UN Regulation No. 129 (Enhanced Child Restraint Systems)

Proposal for draft Supplement 6 to the 03 series of amendments to Regulation No. 129 (Enhanced Child Restraint Systems)

Submitted by the expert from Spain*

Figure 6
Minimum distance for lateral impact

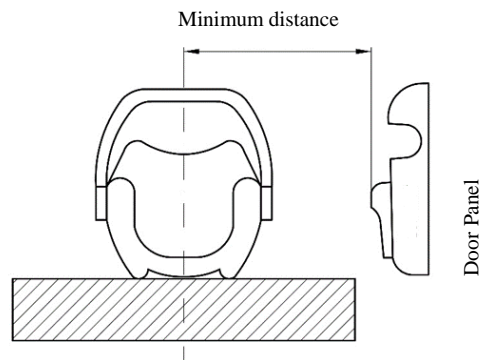
For each test, the initial position of the side impact door panel relative to the bench shall be adjusted according to the minimum distance between the vehicle's door panel and the centre of the seating position as shown in figure 6.
